MODBAR TECHNICAL BULLETIN  
#26  
**Wand spacer on new steam Tap**

We would like to inform you about a recent modification in the wand assembly of the new steam tap.

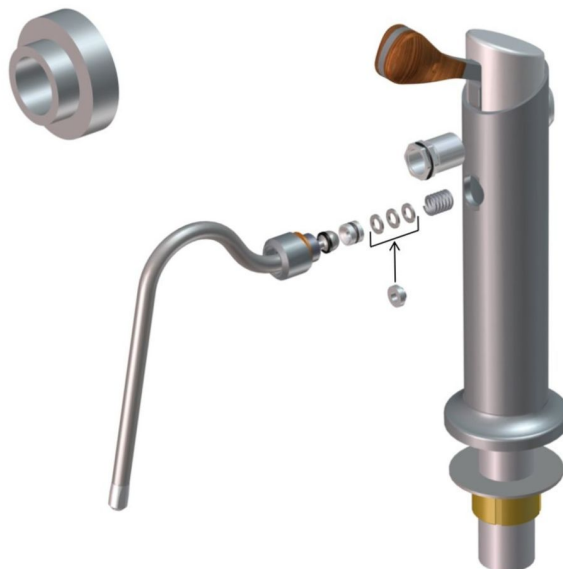
To ensure a more precise pre-load of the spring, the 3 washers L1003 have been substituted with a new part, which is machined with very reduced tolerances.

Since the washers were not enough precise for this application, they could make the joint be more or less tight, depending on their thickness. That can make the wand be loose or damage the teflon seal, which can, in some cases, occlude the steam pathway and reduce the steam pressure when the steam wand is fully upright.

This modification takes effect from serial number MB001493 and it's easily retrofittable on previous taps.

The new part is available for order from Nuova Ricambi with code **F.3.113**.
